Wello Planning	Commission weeting of 3/10/05
Project No. Associated Cases Council Bill Council District School District Requested by	Proposed Amendment to the Bellevue Community Plan: 2003 Update None None 35 – Tygard 9 – Norris Hawkins Partners, Inc., applicant for Westside Property Holdings, LLC, owner
Staff Reviewer Staff Recommendation	Wallace Approve with Special Policy, including height restrictions
APPLICANT REQUEST	Change the land use policy from Residential Low Medium Density (RLM) to Residential Medium Density (RM) for approximately 32.8 acres for property located at the southern terminus of Vaughns Gap Road and the southern terminus of Highland Park Drive, including the applicant's property at 11 Vaughns Gap Road (10.7 acres)
Existing Land Use Policy Residential Low Medium Density	RLM policy is intended for existing and future residential areas characterized by densities of two to four dwelling units per acre. The most common housing type found in these areas is single family detached, although other types may also be found, such as duplexes and low-density townhouses and apartments.

Project No. Project Name Associated Case Council District School District Requested By

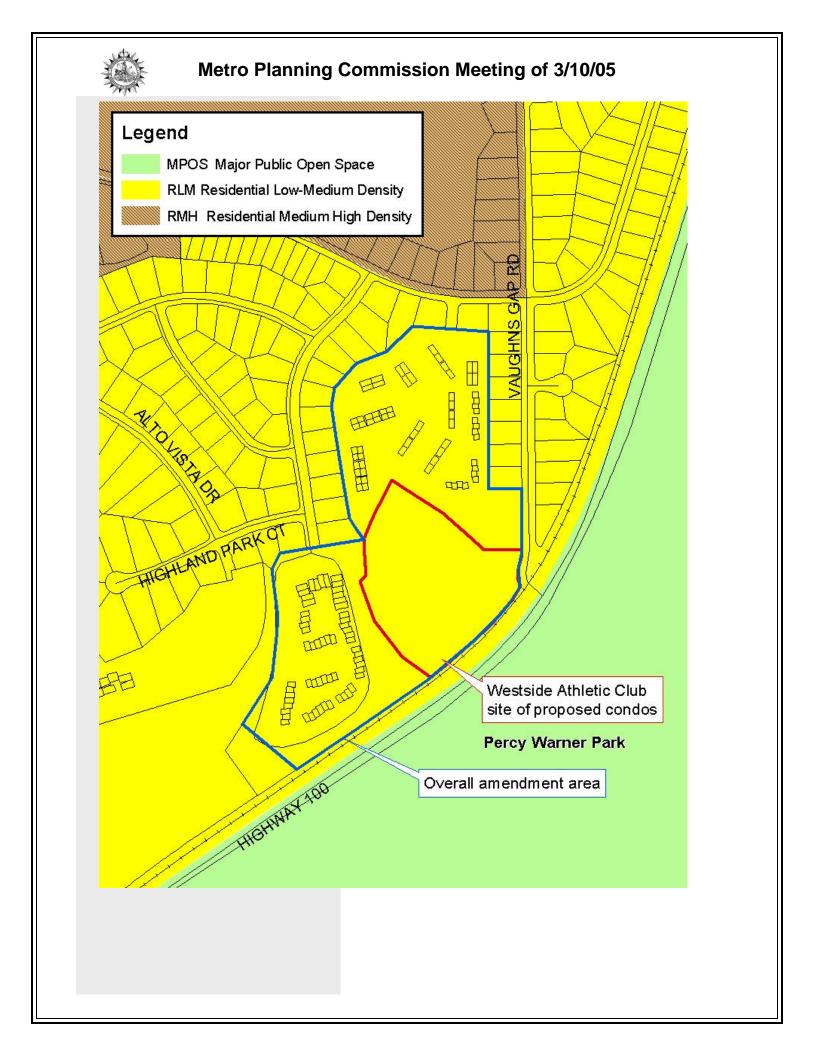
area. These are the Harpeth Glen condos (5.27 dus/acre) and Belle Meade Highlands condos (8.83 dus/acre). The graphic shows both the amendment area requested by the applicant and the overall amendment area as expanded by staff.

Staff believes that the policy change would be a reasonable one because the Westside Athletic Center property is sandwiched between existing medium density housing and would be a completion of that pattern. Application of RM policy here would to a large degree recognize a situation that has been in existence for a long time and, if responsive to the existing scale of development and to hillside considerations, would provide for compatible infill.

Special Policy 7 applies to an approximately 33 acre area at the end of Vaughns Gap Road and Highland Park Drive, adjoining the railroad tracks. Much of this area is already developed with medium density housing and an athletic club. Existing buildings range from one to three stories in height. The intent is for the height of new buildings to be compatible with existing buildings in this area, respect the views from the scenic corridor and nearby park, and respond sensitively to hillside development considerations. Therefore, the height of new buildings in this special policy area shall not exceed three stories.
